RE: In the Matter of Federal-State Joint Board on Universal Service -
CC Docket No. 96-45

**Preliminary Review
of the
Hatfield 3.1 Model**

**presented by US West and Sprint
with INDETEC International
April 7, 1997**

To illustrate this problem, the diagram below contains 4 stylized CBGs: A, B, C and D. Each oval represents 10 households for a total of 100 households per CBG.

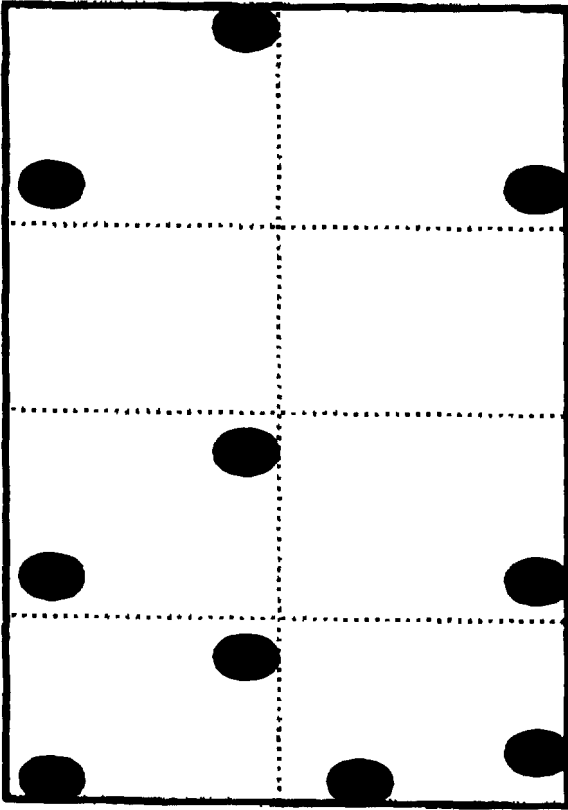
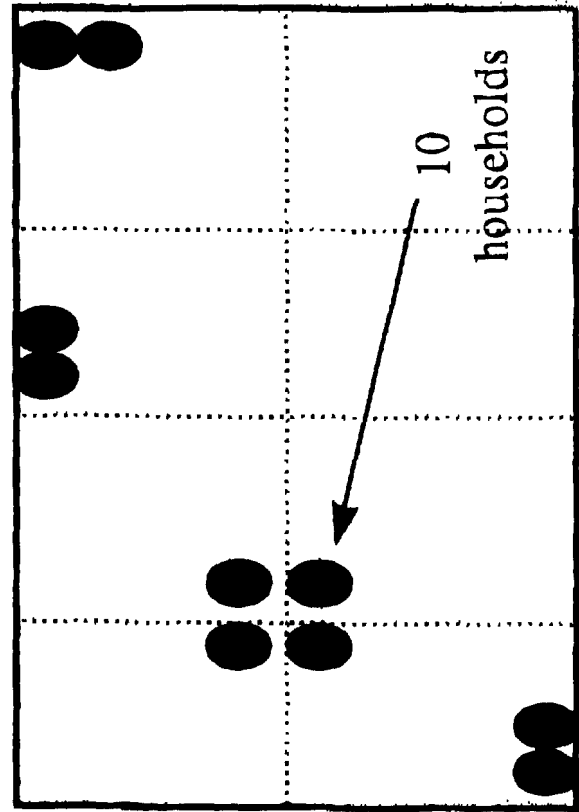
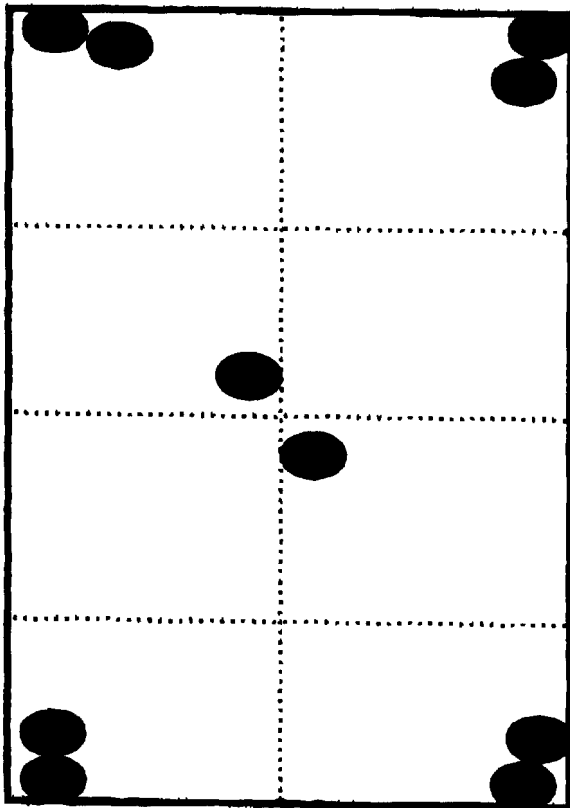
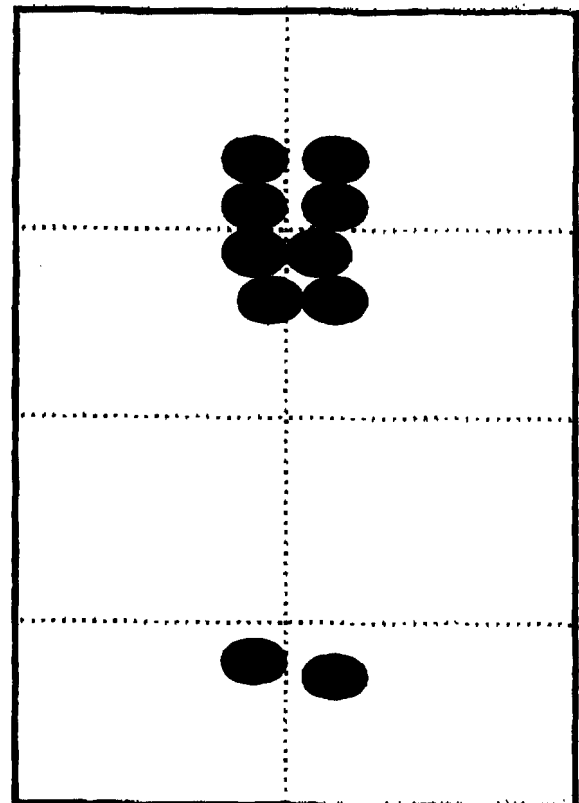
Each stylized CBG has the same land area, same number of census blocks (8, defined by the dotted line), same amount of unpopulated area (25%). However, in certain CBGs the customers are clearly situated in groupings or “clusters”. The

CBG labeled “A” shows 5 clusters. “C” shows 2 clusters. “D” shows 4 clusters and “B” does not show any obvious clusters.

- *The grouping algorithm in the Hatfield Model 3.1 would ignore the existing clusters, and build the same number of clusters, four (4), in every CBG. Eighty-five percent of customers would be placed within these 4 clusters (85% is the Hatfield default value).*

The only criteria for determining the number of clusters used in the Hatfield model is the amount of unpopulated area, which is the same in CBGs A, B, C and D.

- *More importantly, the size of the four clusters would be exactly the same for each of the four CBGs, ignoring the actual amount of area in which customers are located.*

- *In addition, the number of customers in each cluster would be exactly the same for each of the four CBGs.*

Each Hatfield cluster is constructed to contain $1/4^{\text{th}}$ of 85% of customers. In doing this, existing clusters (such as those found in CBG “C”) are ignored by the model.

HATFIELD 3.1 **LOT SIZING FOR 100 SQUARE FOOT LOT**

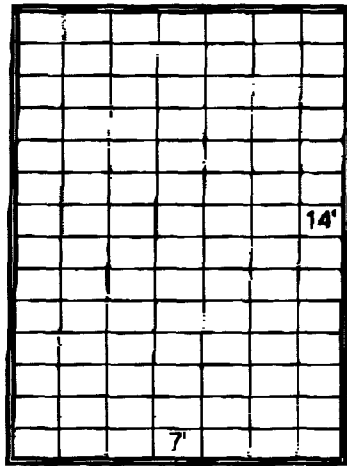
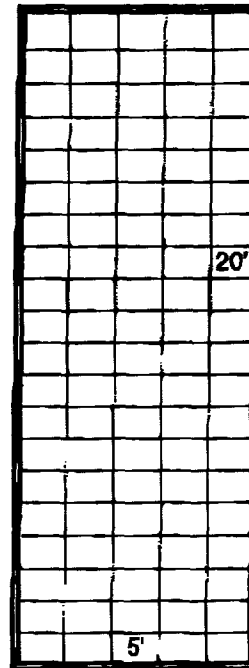
In building the lot sizes, the Hatfield model assumes that every lot is twice as deep as it is wide. Without comment on the accuracy of that assumption, let it be said that the calculation to reflect that assumption is flawed. The calculation methodology is to take the square root of the side, and multiply that by $\frac{1}{2}$ to determine the lot frontage. They then multiply the original side by 2 to calculate the depth. Unfortunately that yields a depth to frontage ratio of 4:1, not 2:1.

Placing illustrative numbers into the description may help describe the errant situation. If the lot were 40,000 square feet, the Hatfield model would take the square root of that to determine its side as 200 feet. It would then (incorrectly) multiply that by .5 to calculate the frontage (incorrectly) at 100 feet. It would then go back to the original side of 200 feet and multiply that by 2 to come up with a side of 400 feet. That results in a side of 400 feet and a front of 100 feet - - a 4:1 ratio of depth to frontage - - with resultant construction changes as well.

What Hatfield 3.1 says it does.

.5 * Square Root of 100
 = 5 on Front

That means
 20' deep.

What Hatfield 3.1 actually does.

This miscalculation flows through to distribution area and investment results.

The proper multiplier for the frontage should be .7070, not $\frac{1}{2}$.

Correct formula should be: .707 * Square Root of Area
